**UNINSURED UNITED PARACHUTE TECHNOLOGIES, LLC.**

DATE: FEBRUARY 12, 2013 SERVICE BULLETIN #20121106 - REV 1

SUBJECT: "Reserve Staging Loop" with support washer. We (manufacturer) require the washer be removed. At the next scheduled repack cycle, remove the washer from the bungee staging loop and tie a double over-hand knot as instructed below and reinstall.

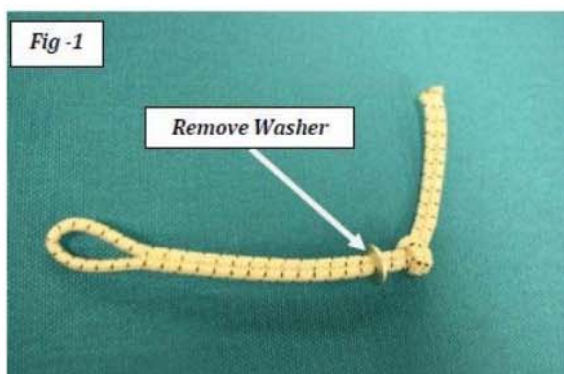
BACKGROUND: During recent inspections prior to repacking the reserve, extra normal wear was found on the reserve closing loop. Further investigation indicates that Vector systems fitted with a (bungee) "Reserve Staging Loop" with support washer may experience this problem. Some washers have sharp edges which had caused minor damage to the closing loop. Thus far, loop damage seen in the field following a 365-day repack cycle has not been considered serious, but is a concern. This Product Service Notification provides a safe solution without altering the function of the staging loop.

SERVICE BULLETIN: At the next scheduled inspection/repack cycle remove the support washer from the "Reserve Staging Loop." (Fig-1) Inspect the internal and external condition of the staging loop and replace it if any damage is found. Tie a "Double Over-Hand Knot" at the prescribed location. The staging loop length should be 1-inch (25mm) shorter than the reserve closing loop. Mark the loop at the desired length. Fig-2 shows a single over-hand knot. Fig-3 shows the loop end passing one more time through to create the double
